PROJECT: North Castle NY - JG Petrucci DATE: 7/12/2021
 2179-99-009
 SUBJECT: 94 Business Park Drive TRANSMITTAL ID: 00006
 PURPOSE: For your use VIA: Info Exchange

**RE: Armonk Fairview, LLC &
Aggro and Brassi, LLC
Proposed Warehouse
Section 108.03; Block 1; Lot 50
94 Business Park Drive
Town of North Castle (Armonk)
Westchester County, NY
DEC #2179-99-009**

The following are responses to an engineering review letter prepared by Kellard Sessions dated March 5, 2021:

SCALE: (H) 1" = 30'
 (V) 1" = 10'

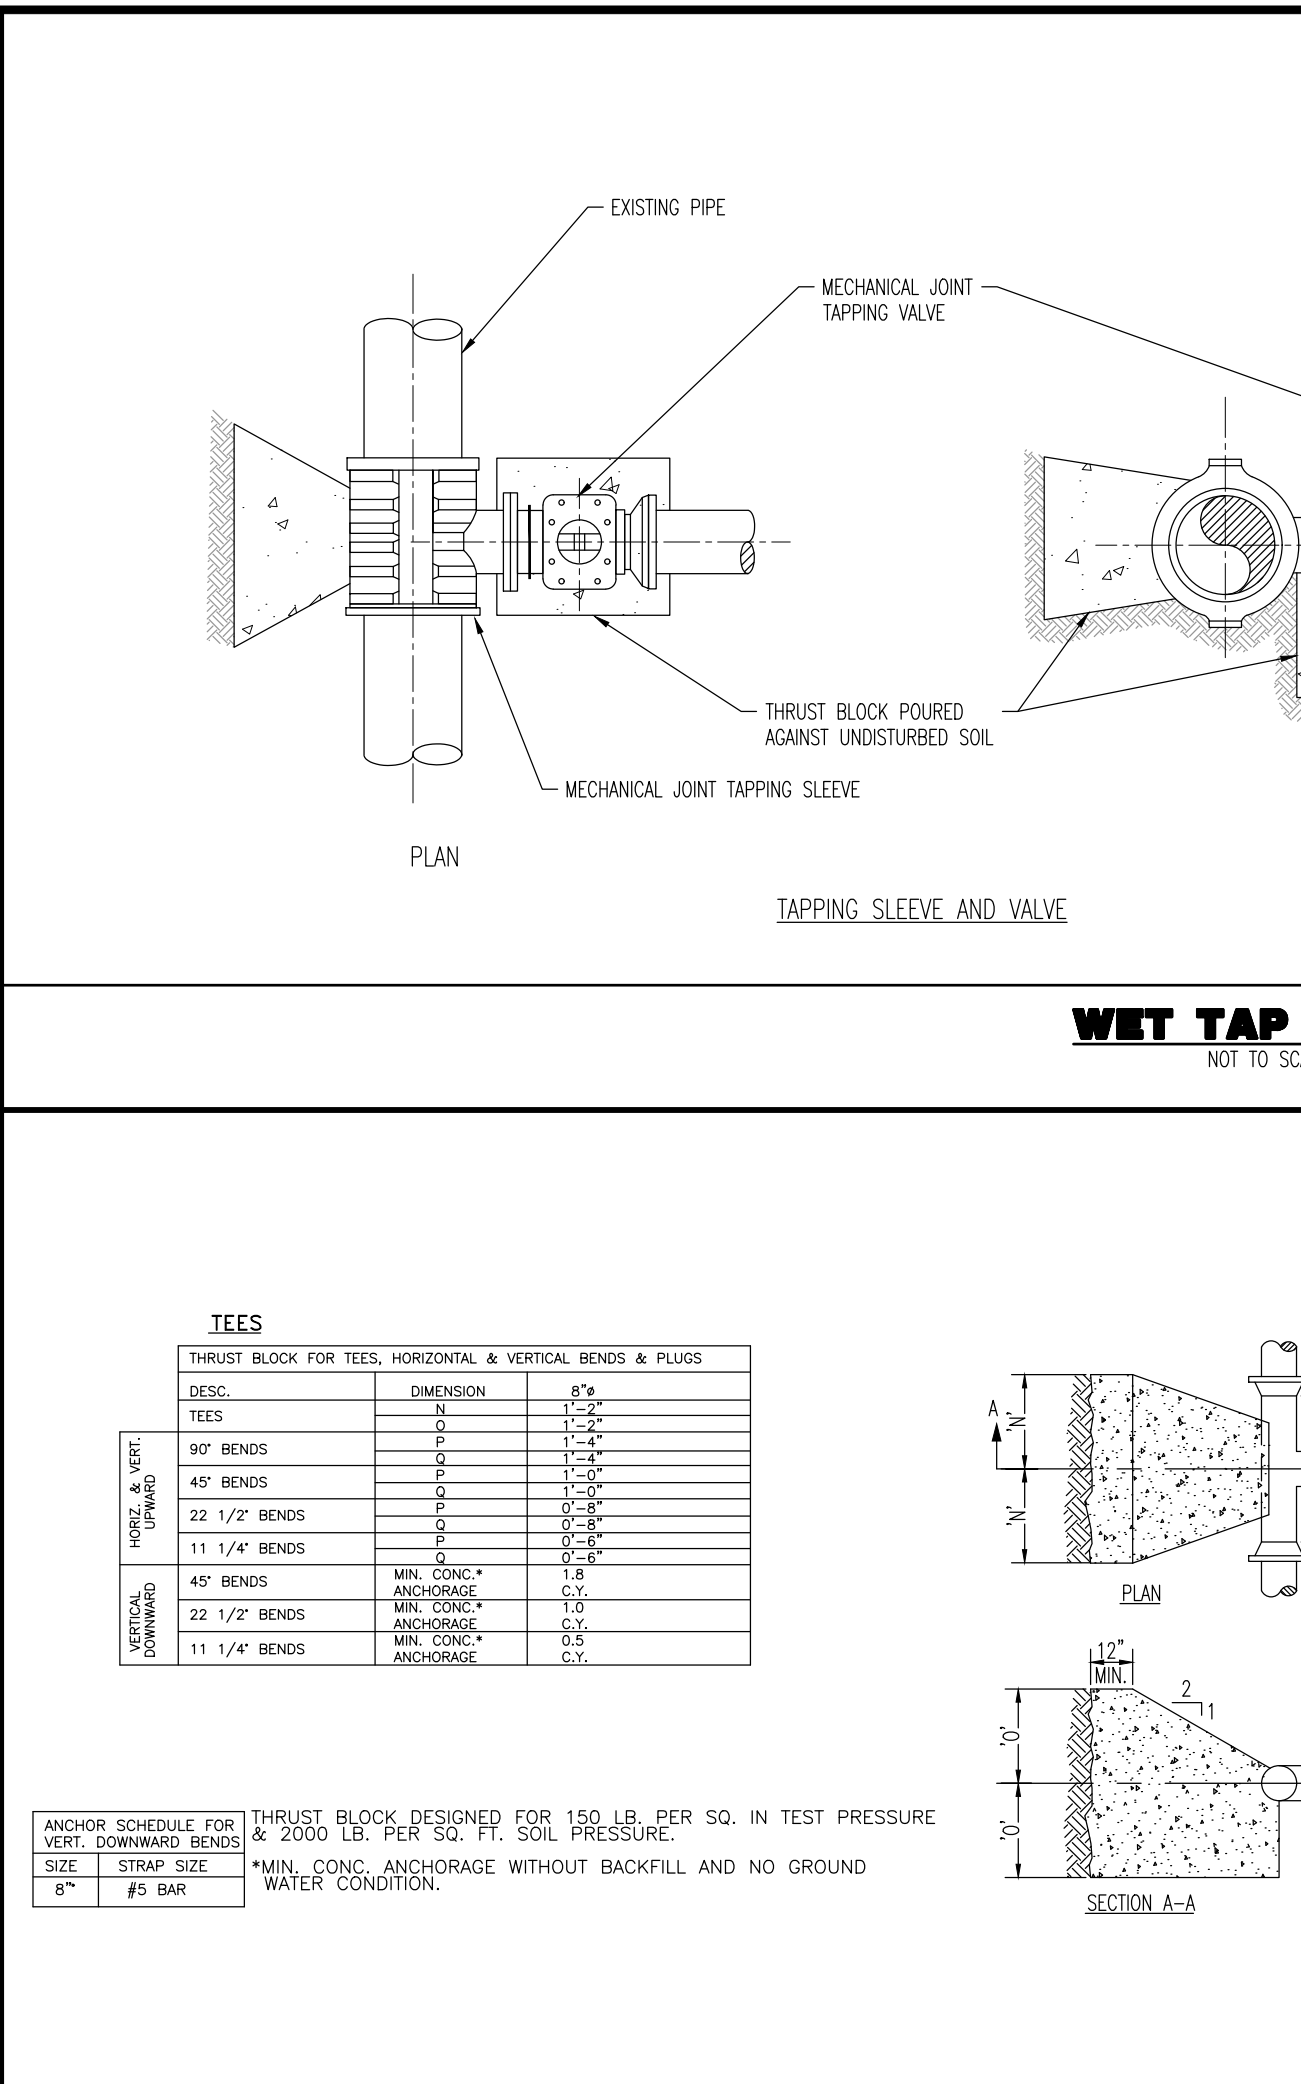
- l. The construction phasing and sequence described on the Stormwater Pollution Prevention Plan (Sheet 8 of 13) shall be expanded based on the phasing described above, as well to include provisions for temporary sediment basins, protection of drainage facilities throughout construction, conversion to allow stormwater mitigation systems to go on-line, wetland mitigation, etc.

The Stormwater Management report will be revised to include 100-year design flow following approval of the proposed water quality design.

FIRE TRUCK CIRCULATION

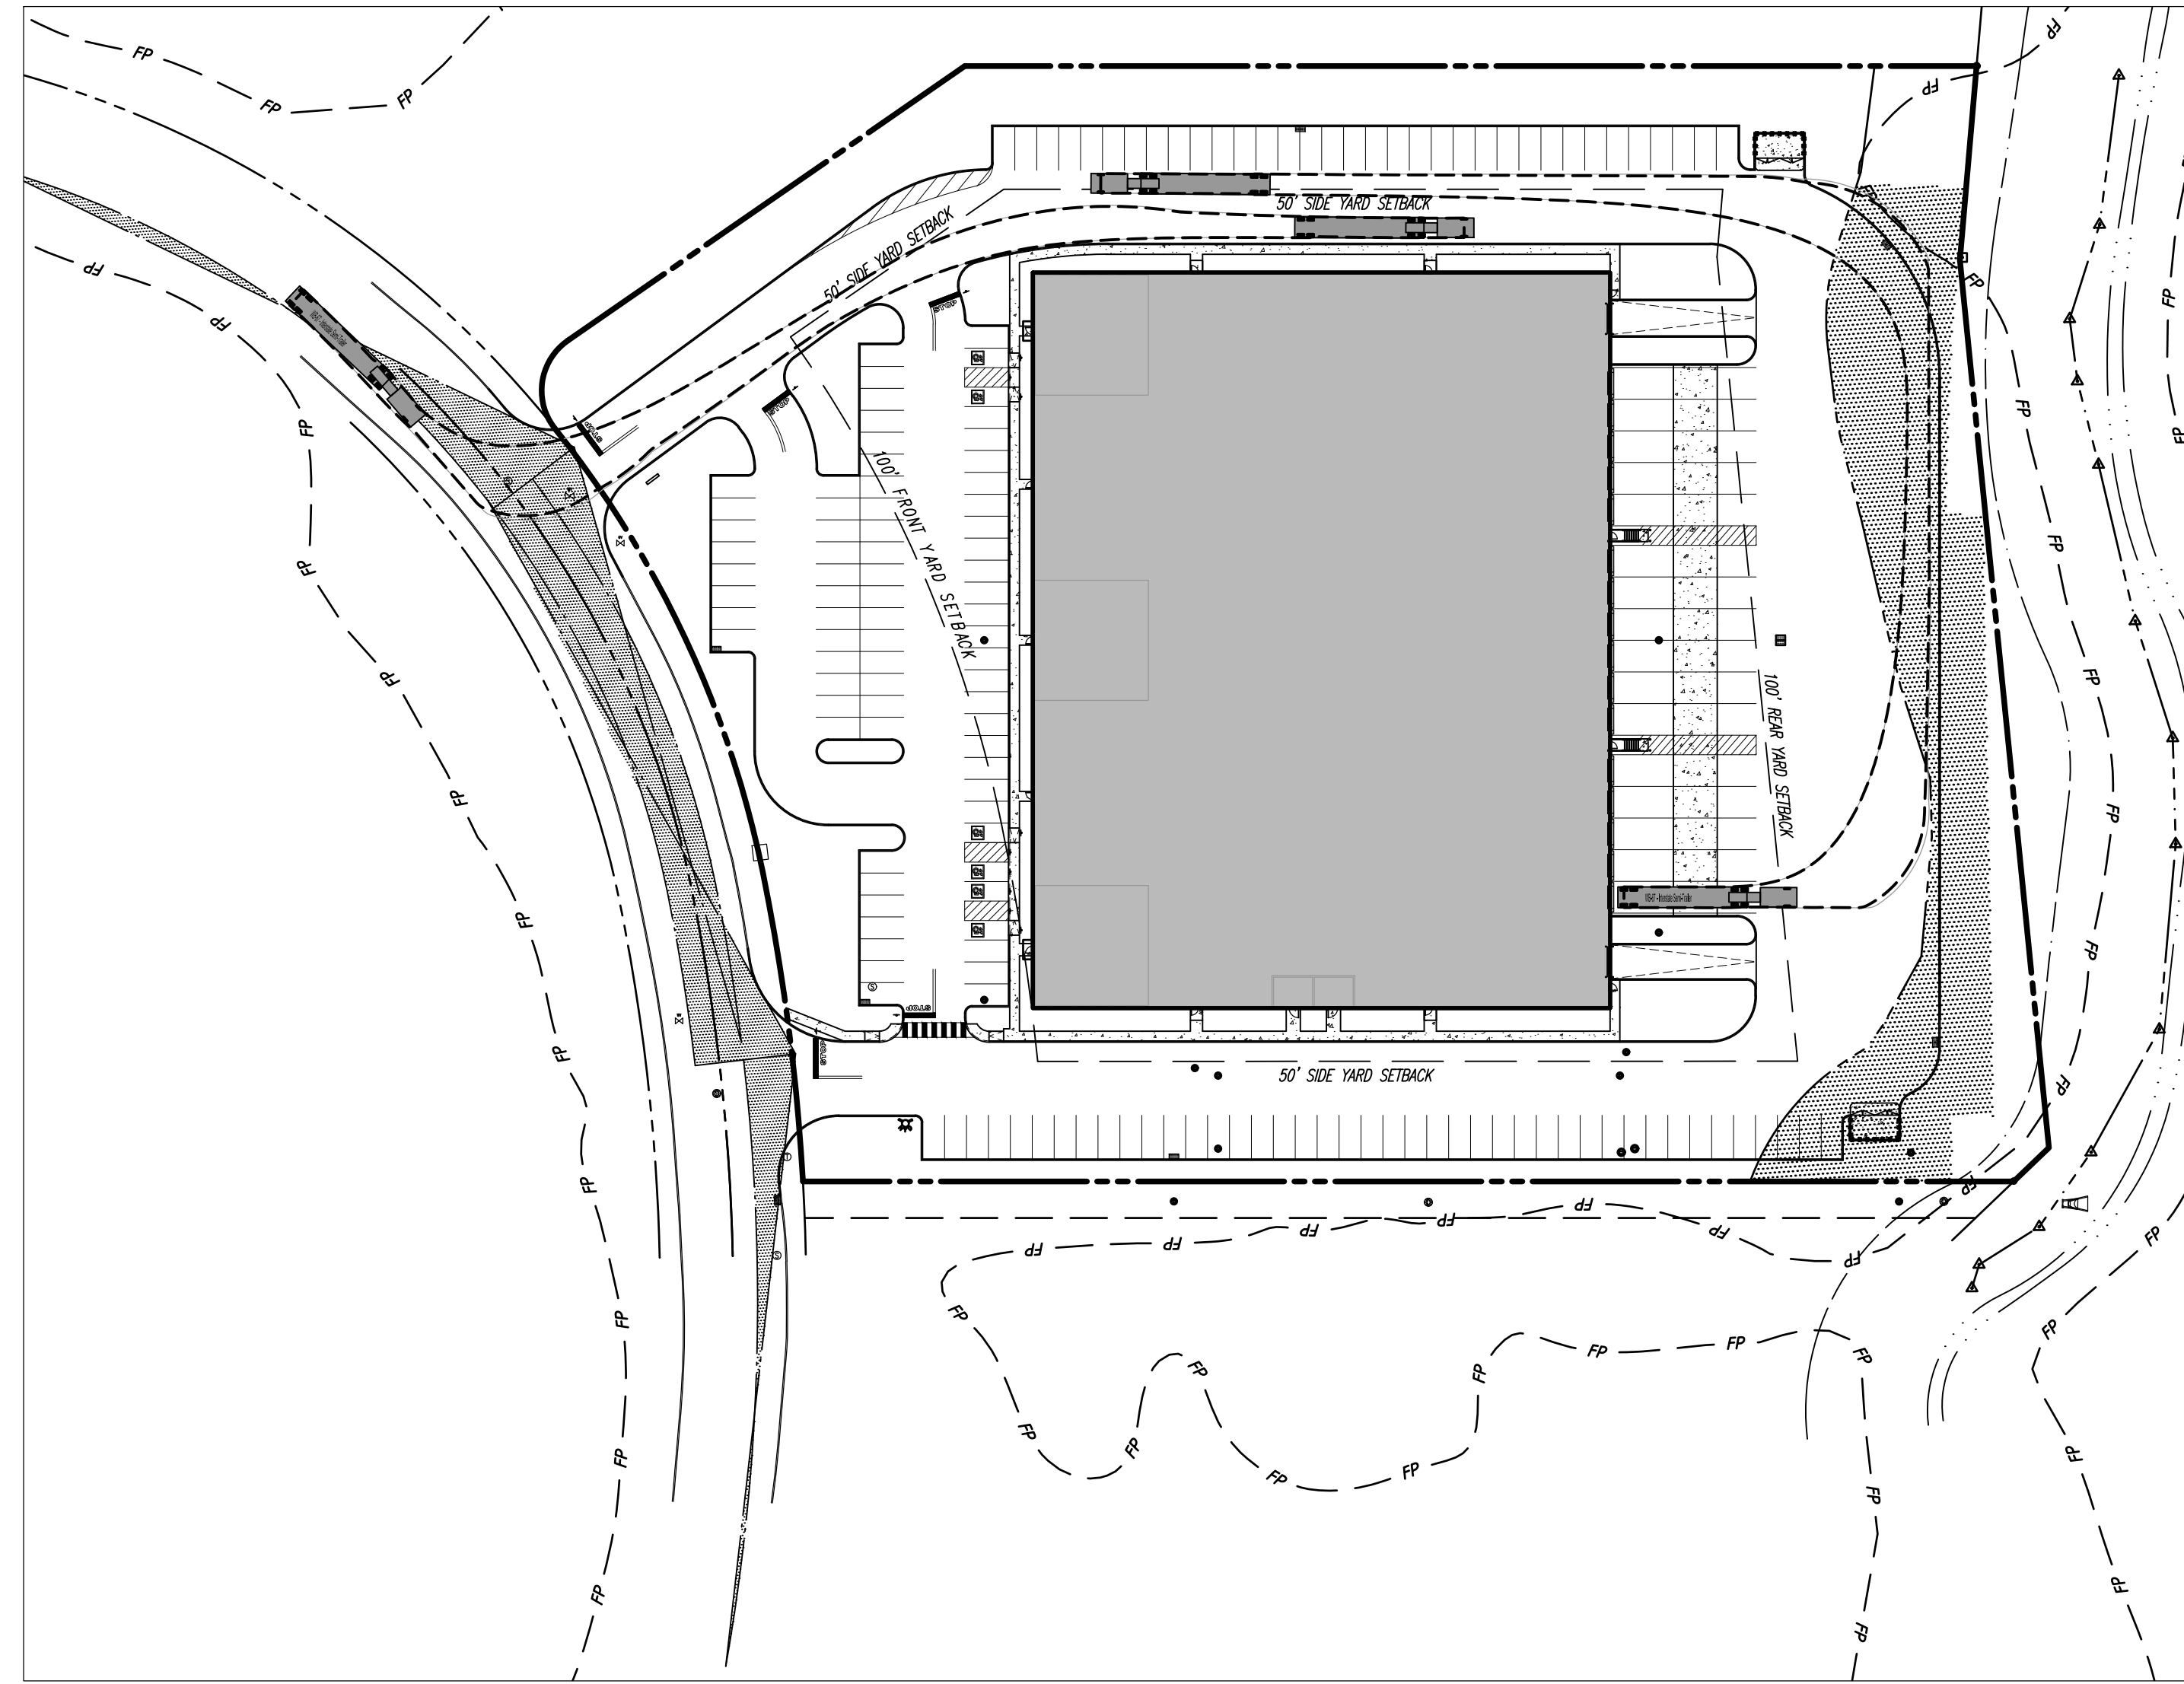
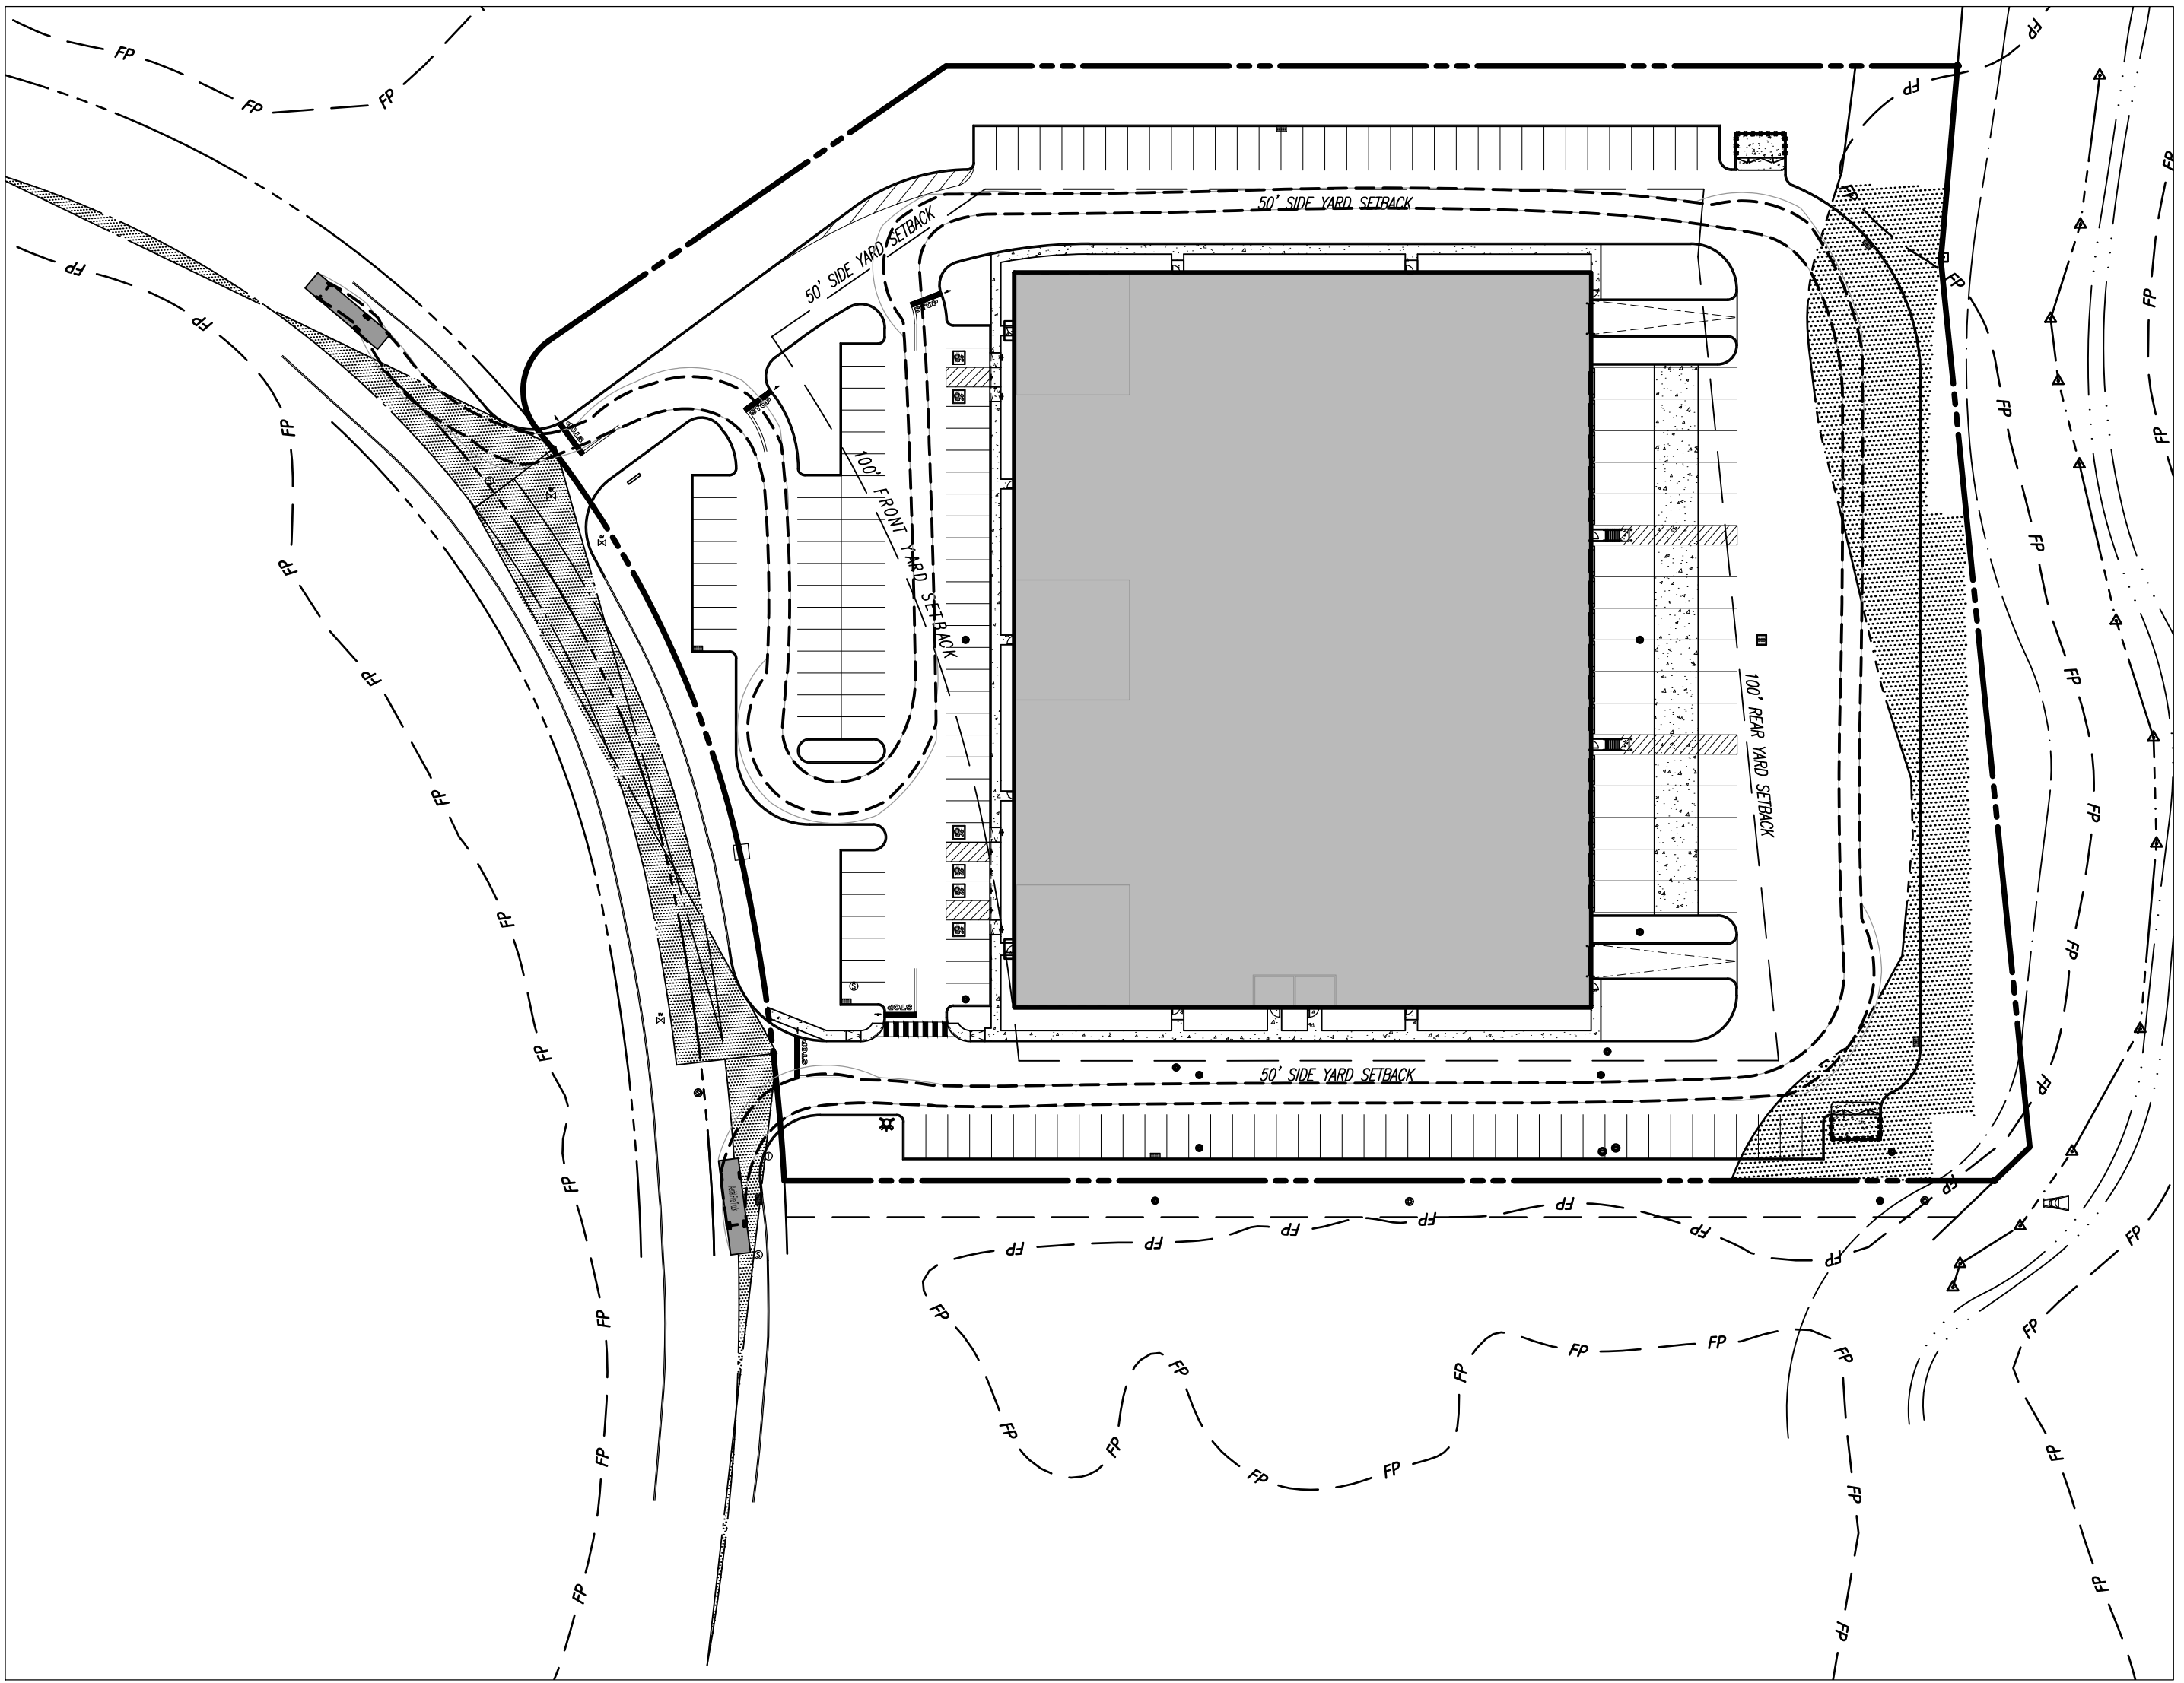
9. The applicant should illustrate turning movements, around the proposed building and exiting the site, for fire apparatus vehicles and tractor trailers of a size anticipated to utilize the site. The plan should be referred to the Armonk Fire Department for review of adequate emergency access and location(s) of proposed fire hydrant(s).

The plans have been updated to illustrate turning movements.
